CITY OF ALBUQUERQUE

Re: Albuquerque School of Excellence
13201 Lomas Blvd NE Albuquerque NM 87112
Traffic Circulation Layout
Engineer's/Architect's Stamp 11-07-2018 (J22D050)

Based upon the information provided in your submittal received 11-08-2019, the above referenced plan cannot be approved for Building Permit until the following comments are addressed:

ABQ SCHOOL OF EXCELLENCE	DRAWN BY pm
	TRAFFIC CIRCULATION LAYOUT	DATE 11-5-19
		DRAWING 2019068-SP
		SHEET # SP-1
		JOB # 2019068

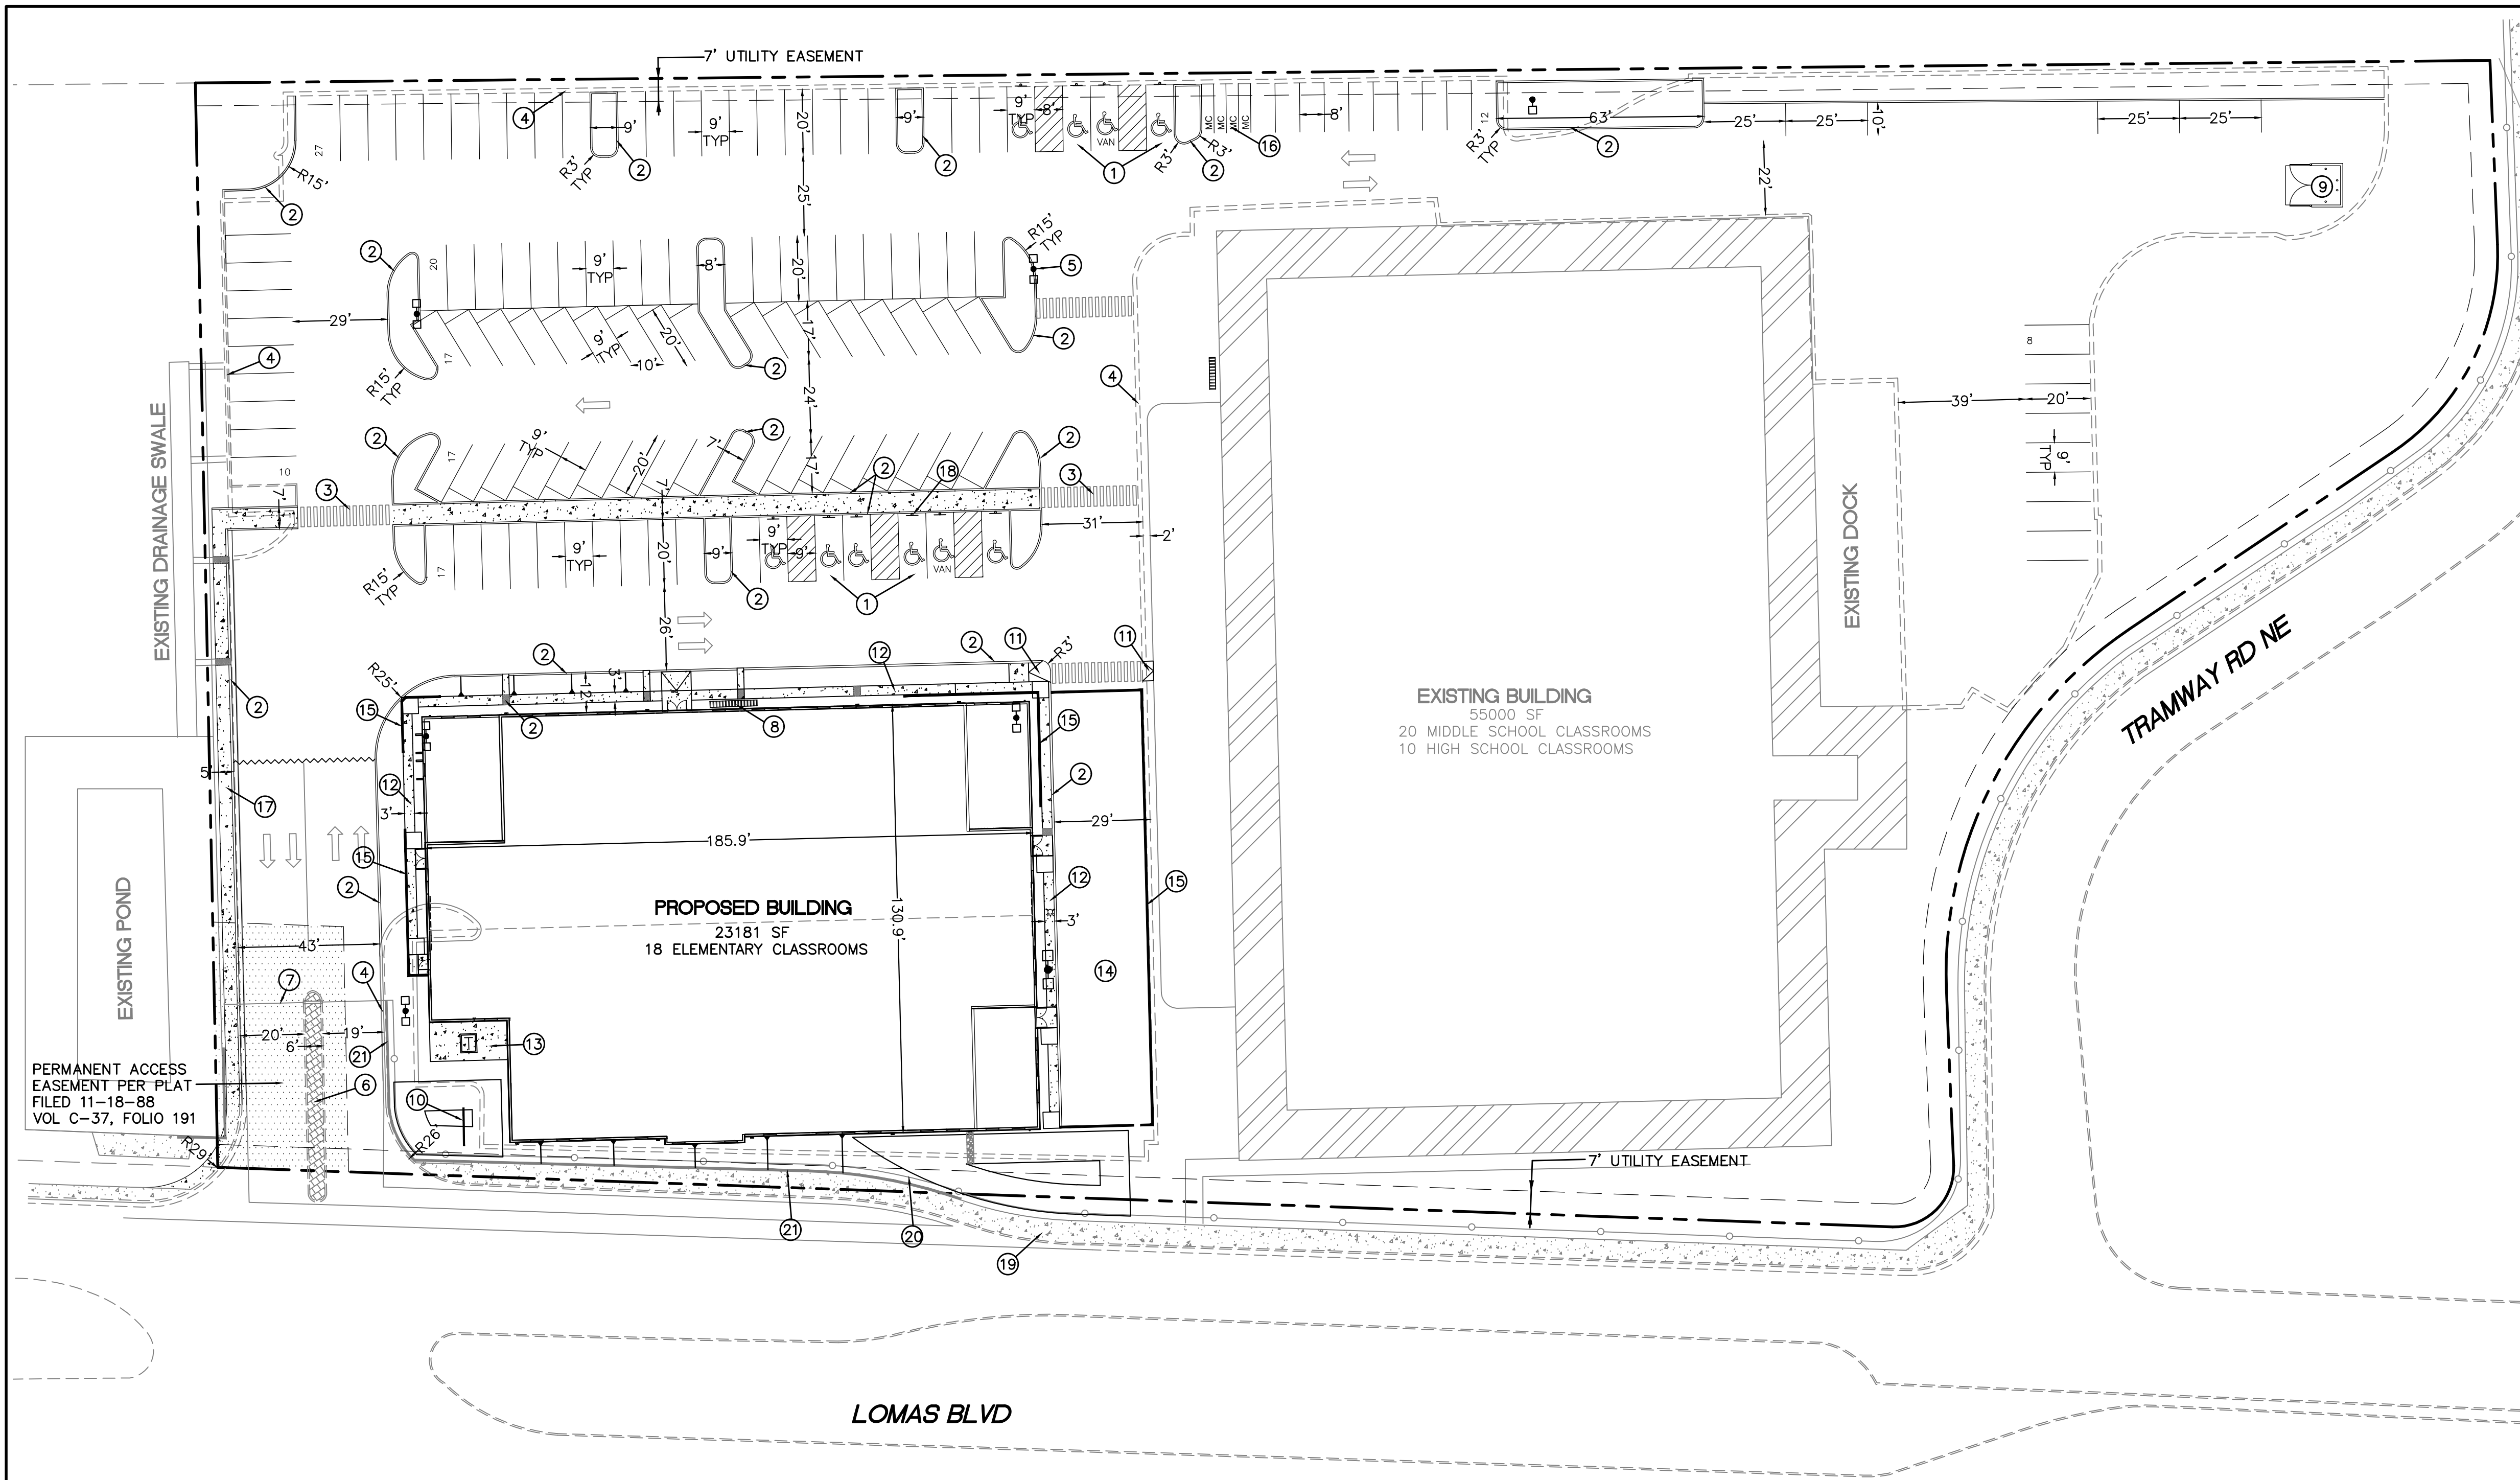
1. The ADA accessible parking sign must have the required language per 66-7-352.4C NMSA 1978 **"Violators Are Subject to a Fine and/or Towing."** Please call out detail and location of signs.

2. The ADA access aisles shall have the words **"NO PARKING"** in capital letters, each of which shall be at least one foot high and at least two inches wide, placed at the rear of the parking space so as to be close to where an adjacent vehicle's rear tire would be placed. (66-1-4.1.B NMSA 1978)

3. Motorcycle parking spaces shall be designated by its own conspicuously posted upright sign, either free-standing or wall mounted per the zoning code.

4. All bicycle racks shall be designed according to the following guidelines:
 - a. The rack shall be a minimum 30 inches tall and 18 inches wide.
 - b. The bicycle frame shall be supported horizontally at two or more places. Comb/toaster racks are not allowed.

- c. The rack shall be designed to support the bicycle in an upright position. See the IDO for additional information.
 - d. The rack allows varying bicycle frame sizes and styles to be attached.

- e. The user is not required to lift the bicycle onto the bicycle rack.
 - f. Each bicycle parking space is accessible without moving another bicycle.

5. Bicycle racks shall be sturdy and anchored to a concrete pad.
6. A 1-foot clear zone around the bicycle parking stall shall be provided.
7. Bicycle parking spaces shall be at least 6 feet long and 2 feet wide.

8. Refuse vehicle maneuvering shall be contained on-site. The refuse vehicle shall not back into the public right of way.; provide a copy of refuse approval.
